# UNITED STATES PATENT AND TRADEMARK OFFICE

APPLICATION NO.	FILING DATE	FIRST NAMED INVENTOR	ATTORNEY DOCKET NO.	CONFIRMATION NO.
10/689,813	10/20/2003	Richard Cooper	3060-3	4362

## Office Action Summary

## DETAILED ACTION

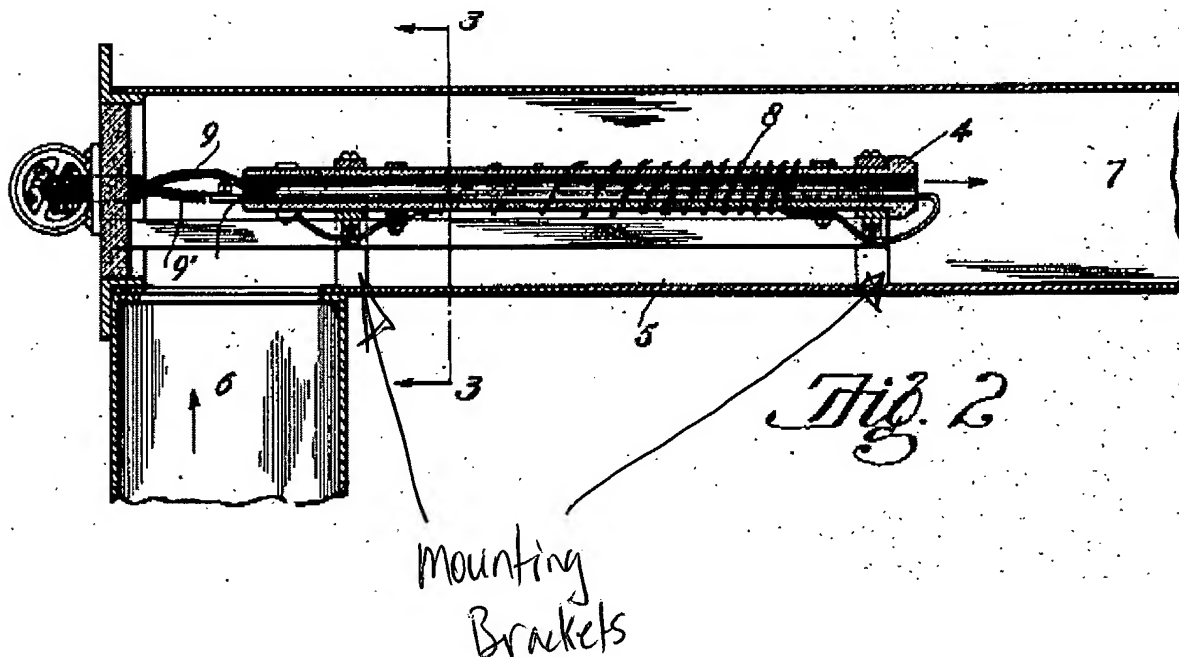
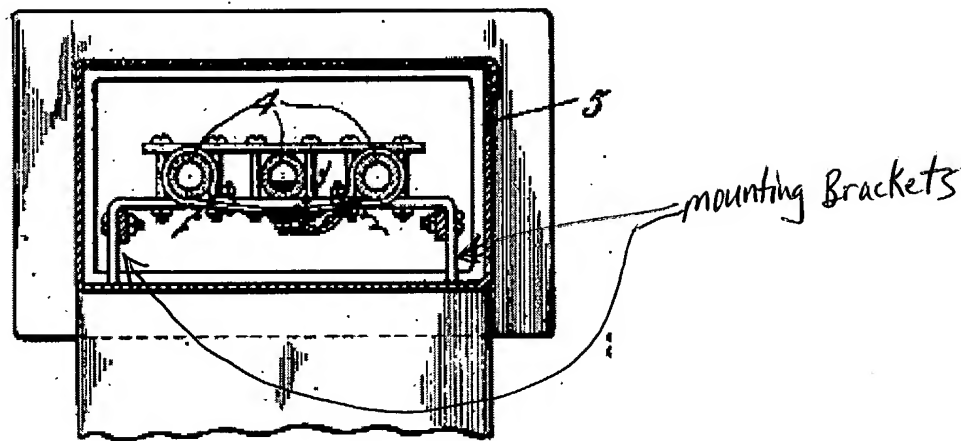
Claims 4-8, 11, 12, 19, and 20 are rejected under 35 U.S.C. 103(a) as being unpatentable over Park (US 2003/0116559) in view of Burger (US 1,491,194). The claims differ from the previously cited prior art in calling for the housing to have one mounting bracket protruding from an inner surface of the housing and the tubes to be mounted in the mounting bracket. Providing a surrounding housing for a tubular heating element and providing a protruding mounting bracket from the inner housing surface is conventional and well known in the art as evidenced by Burger (US 1,491,194) noting surrounding housing 5 and unlabelled mounting brackets that protrude from the housing's inner surface. Figs. 2 and 3 of Burger (US 1,491,194) are reproduced below to clearly show the mounting brackets.

As shown in Burger (US 1,491,194), such an arrangement confines airflow to a defined volume dictated by the housing and centralizes the heater tubes within the housing. In view of Burger (US 1,491,194), it would have been obvious to one of ordinary skill in the art to provide a surrounding housing and mount the heater tubes in brackets protruding from the housing so that air to be heated is confined to a defined volume dictated by the housing and the heater is centralized within the airflow thus more uniformly heating the air.
